Access Compliance Report Public Rights-of-Way (Curb Ramps)

Main Street: SENDERO WAY		Cross Street: ASCENSO AVE		Location:	E
ADA ID: RPRK211117152809	Ramp Type: Type 1 - Perpendicular	Initial Pass/Fail: Pass	Overall Compliance: No	Severity Score:	6

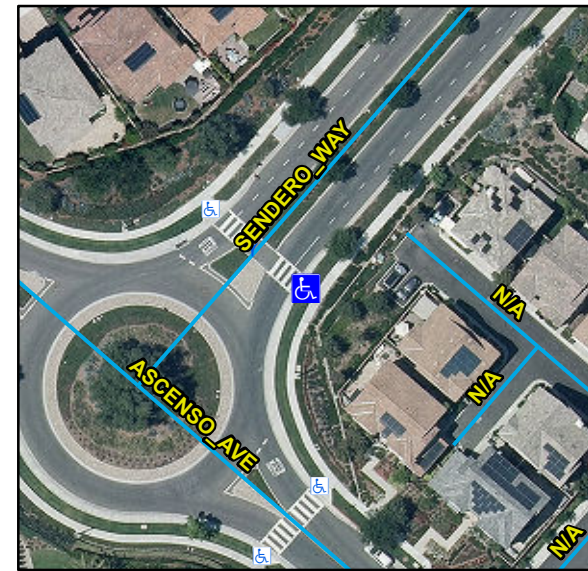
Compliance	Description	Data	Compliance	Description	Data
N/A	Ramp Length (in)	61	N/A	Flare Type LT	
Yes	Ramp Width (in)	60			Sloped
Yes	Ramp Run Slope (%)	8.3	N/A	Flare Slope LT (%)	12.9
Yes	Ramp Cross Slope (%)	1.2	N/A	Flare Traversable LT	No
N/A	Landing Present	Yes	N/A	Flare Type RT	
N/A	Landing Length (in)	50			Sloped
Yes	Landing Width (in)	72	N/A	Flare Slope RT (%)	5.9
No	Landing Run Slope (%)	2.6	N/A	Flare Traversable RT	No
Yes	Landing Cross Slope (%)	0.4	Yes	DWS Provided	Yes
N/A	Landing Movement Obstructed?	No	Yes	DWS Contrast	Yes
	Landing Movement Type	N/A	Yes	DWS Length (in)	36
N/A	Landing Shared	No	Yes	DWS Full Width	Yes
N/A	Clear Space	N/A	Yes	DWS Offset Left (in)	0
N/A	Clear Space To Crosswalk (in)	N/A	Yes	DWS Offset Right (in)	N/A
N/A	Marked Crosswalk 1	Yes	N/A	Marked Crosswalk 2	N/A
	Crossing 1 Direction	NW		Crossing 2 Direction	N/A
	Marked Crosswalk 1 Width (in)	144		Marked Crosswalk 2 Width (in)	N/A

Yes	Ramp Inside Crosswalk 1	Yes	Yes	Ramp Inside Crosswalk 2	N/A
	Crossing 1 Slope (%)	3.5		Crossing 2 Slope (%)	N/A
	Crossing 1 Cross Slope (%)	1.9		Crossing 2 Cross Slope (%)	N/A
Yes	Gutter Ponding	No	Yes	Curb Slope	2.6
Yes	Gutter Lip Height (in)	0		Road Run Slope (%)	N/A
No	Gutter Run Slope (%)	5.5		Road Cross Slope (%)	N/A
No	Gutter Cross Slope (%)	2.3			
Yes	Overall Surface Condition: Acceptable		Yes	Perp Joint Present	Yes
	Cross Gutter Present?	No		Spandrel Present?	No
	Replace Cross Gutter?	N/A		Replace Spandrel?	N/A

Remove & Replace Landing. Remove & Replace Gutter.
